INITIAL FIRE SAFETY INSPECTION REPORT

**JM Fabrics Ltd. (Extension)
24603**

Date: 11-Oct-2023

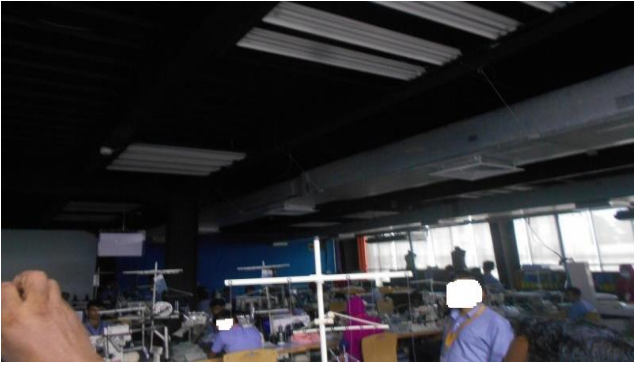
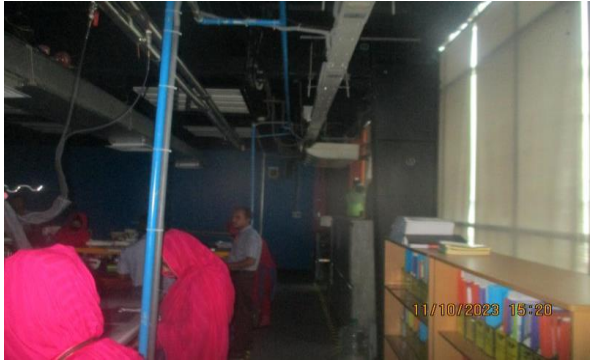
<p>11/10/2023 15:26</p>				
<p>F-5</p>	<p>Fire Rated Construction</p>	<p>Chemical storage area is not separated by fire-rated construction having non rated door and unsealed penetrations and openings.</p> <p>Location: Ground Floor of Building-03</p>	<p>Separate the Chemical Storage area by a minimum 4-hr fire-rated construction. Seal and/or protected all openings to maintain the required fire separations. Follow 2.13 of BNBC-2006. For the case of 4-hr fire separation no opening is permitted.</p>	<p>Within 3 month</p>
 <p>11/10/2023 15:40</p>	 <p>October 11, 2023 3:33 PM</p>
